Re: PLANO ZONING CASE #2022-003

Response to Medical City of Plano's Zoning Exhibits and Explanations

Aspen Court Apartment's Response to Medical City Plano's Zoning Exhibits and Explanations

*Evaluation
of the
Proposed Rooftop Heliport
At
Medical City of Plano*

- 12- Existing Tank Farm
- 3 - C Tower with 3 Helistops
- 13- Aspen Court Apartments

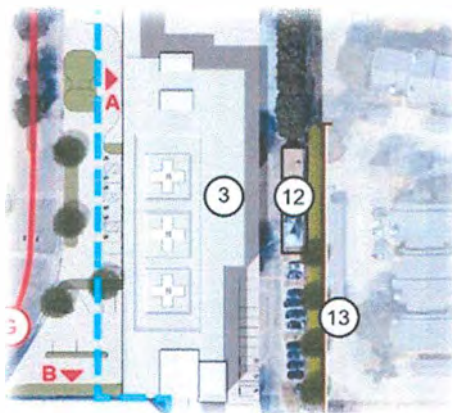
Speaking about safety risks, MCP has an existing chemical tank farm located between C Tower and Aspen Court Apartments. As depicted in the photo below, the location chosen by MCP for the three helistops lies in the immediate "fall range" onto the tank farm should a helicopter accident occur during landing, departure or hovering on the east side of the tower. Most concerning to Aspen Court Consultants and neighborhood residents is that the tank farm contains a 33' high liquid oxygen tank, a 15' tall liquid oxygen tank a $\pm 10'$ tall liquid nitrogen tank and a 22' tall vaporizing unit. In the event of a helicopter accident the chemical reaction of oxygen and aviation jet fuel would be catastrophic to Aspen Court and Parkbluff residents and to MCP employees, patients, caregivers and guests in C Tower.

Photo of Chemical Tank Farm located between C Tower and Aspen Court Apartments. Helistops are to be located directly above tank farm and to the left on top of C Tower. A 33' tall oxygen tank is in foreground.

SHADE & SHADOWS:
DATE: FEBRUARY 14
TIME: 4:30 PM
SUNRISE: 7:11 AM
SUNSET: 6:11 PM

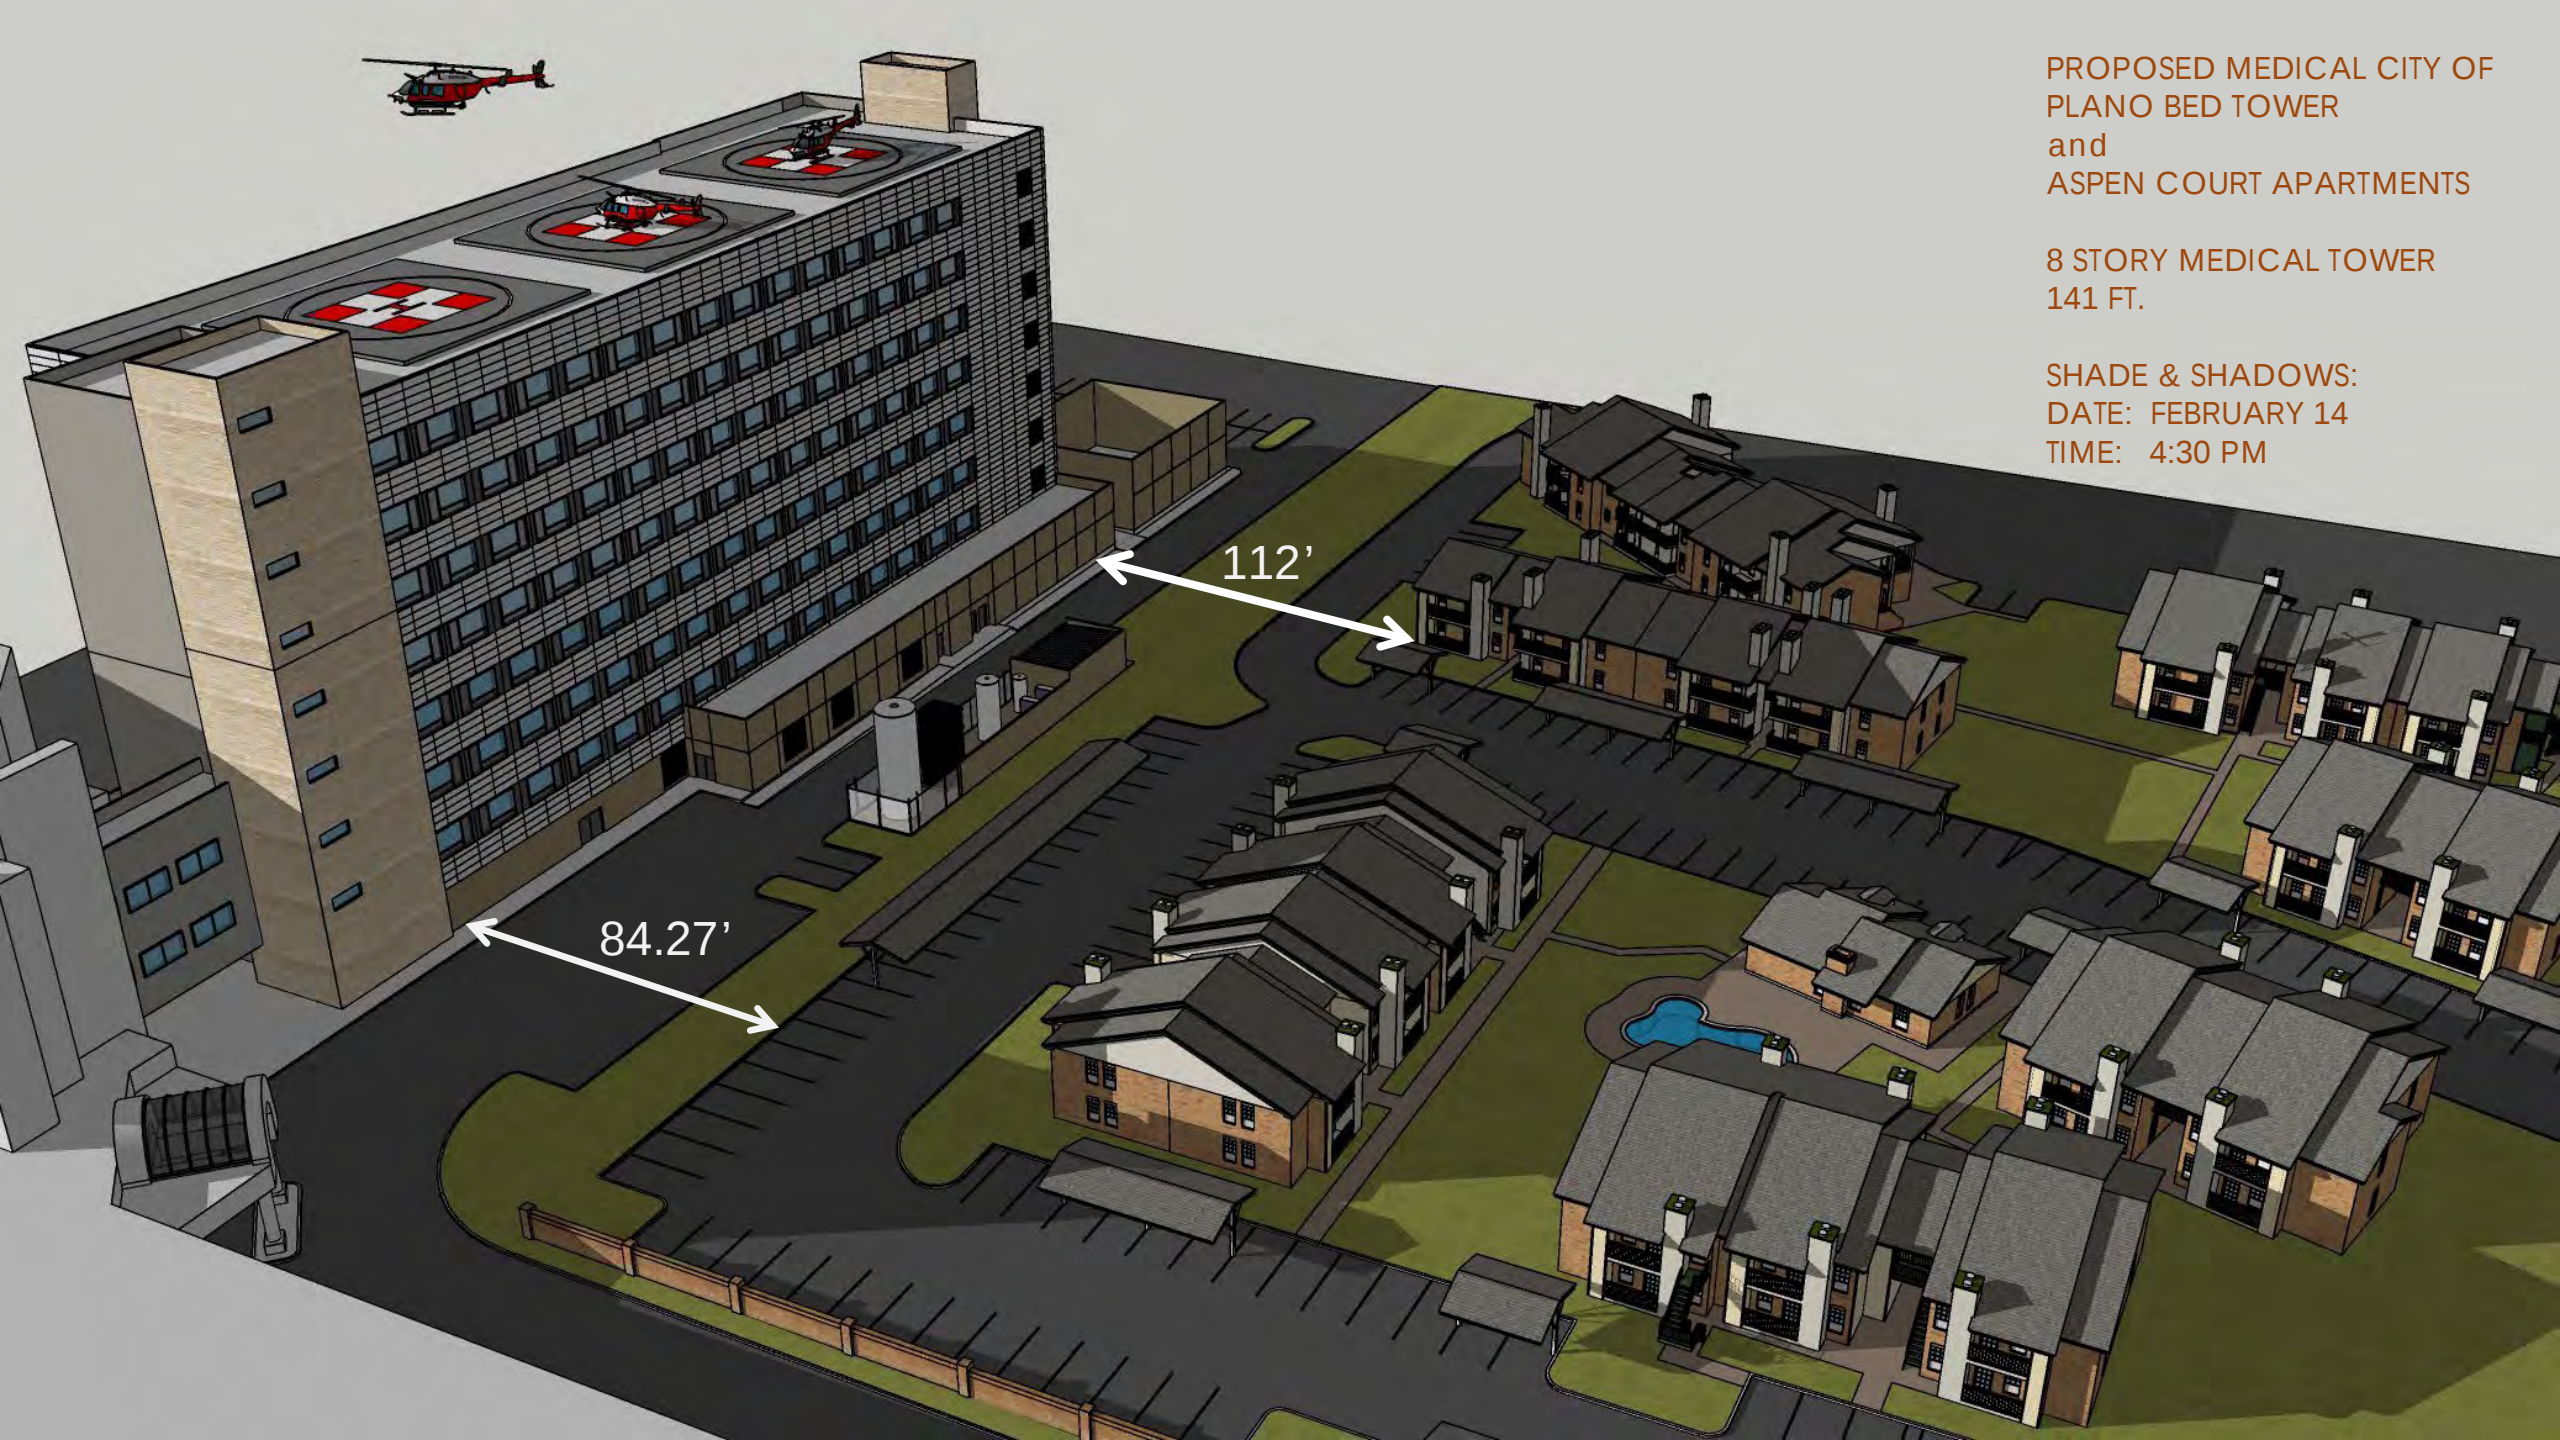
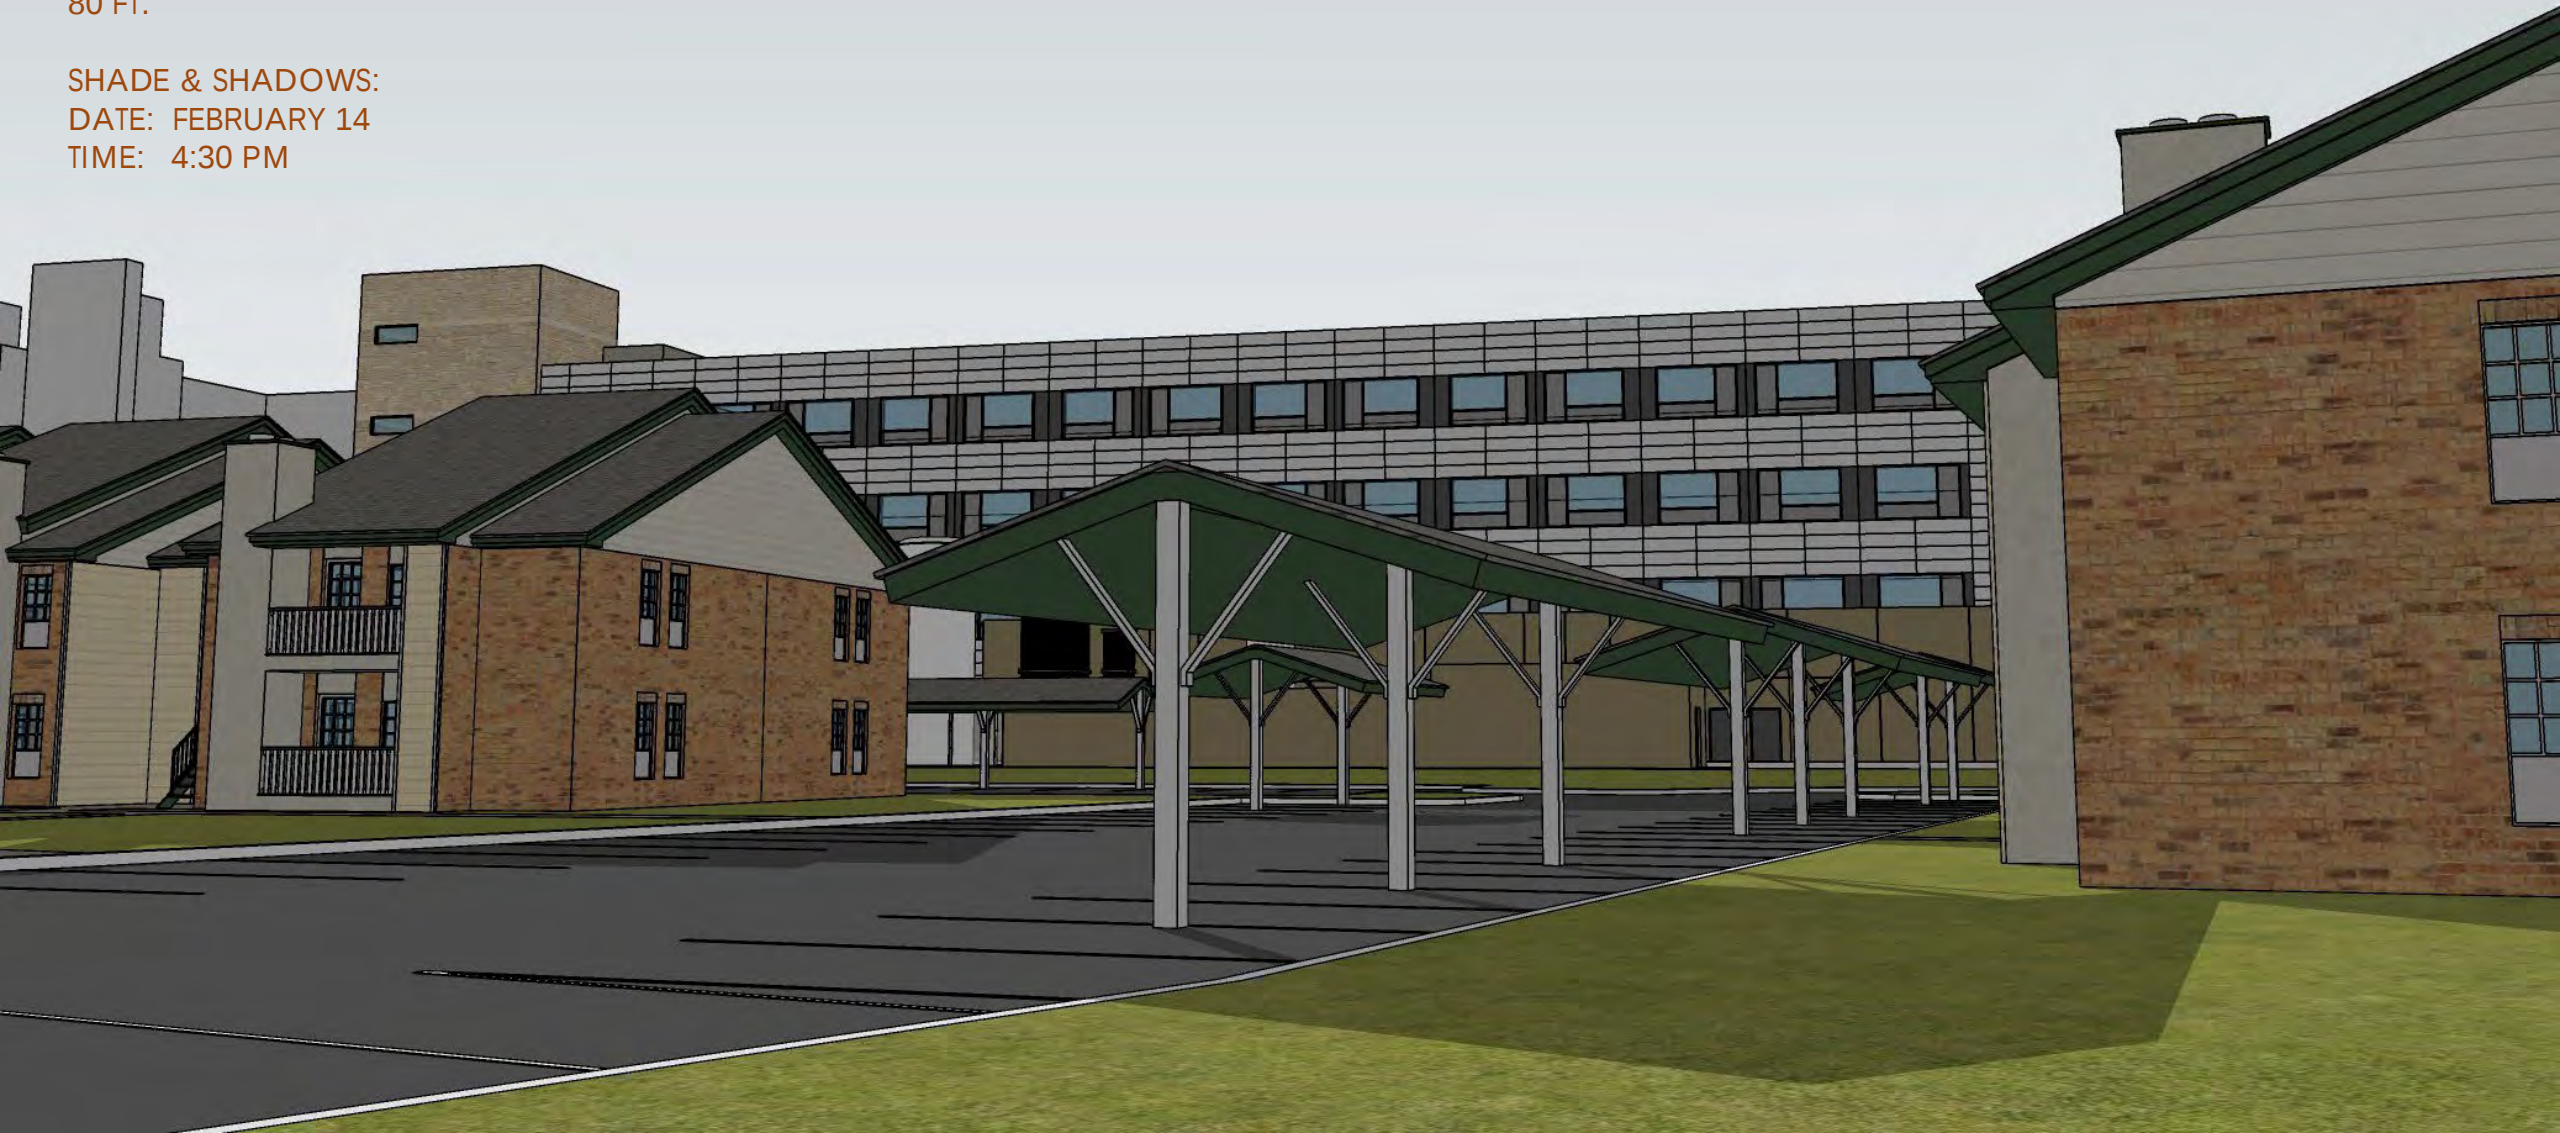
C Tower expansion (adding 4 floors to existing 4-stories) - The Solar/Shadow Study submitted by MCP measures 5 days in the year, covering every season, "and identified limited impact of shadows on the apartment complex". Shadow Study submitted on behalf of Aspen Court was "based on one day of the year in February, with shortest duration of sunlight". These two statements are false and misleading.

MCP issued a false statement regarding February 14th (Aspen Court Shadow Study date) as having the shortest duration of sunlight (sunrise at 7:11 AM and sunset at 6:11PM). Actually, the shortest day of the year occurs on December 21st (sunrise at 7:25 AM and sunset at 5:24PM) per MCP's own Solar/Shadow Study prepared by Perkins and Will. Aspen Court Apartment's color 3-D Shadow Study demonstrates shadows cast on $\frac{3}{4}$ of the property during late afternoons-evenings. However, due to the height of the proposed 8 story tower, with only an 85' setback to the Aspen Court property line will cause the entire west horizon to be visually blocked to Aspen Court's residents.

Moreover, it serves no purpose for the MCP Solar/Shadow Study to include shadows cast at 9:00 AM, 12:00PM and 3:00PM in the afternoon when it is obvious shadows across Aspen Court don't exist. Using a 5:00PM Shadow Study as the latest time period year round by Perkins and Will is misleading as sunsets are as follows per the MCP Study: March 21st -7:39PM, June 21st -8:38PM and September 21st - 7:24PM. It would be more meaningful for their study to include Shadow Studies at 6:00PM to 7:00PM for the previous cited time periods during evening hours when most residents are home.

2. **Shadows cast across Aspen Court by the 8-story C Tower** will cause early night fall for Aspen Court residential units year round due to shadows cast across Aspen's buildings, particularly after 5:00PM. The setback for C Tower is more akin to a 2-story building versus an 8-story structure. The result will be the loss of view toward the western horizon for all residents.
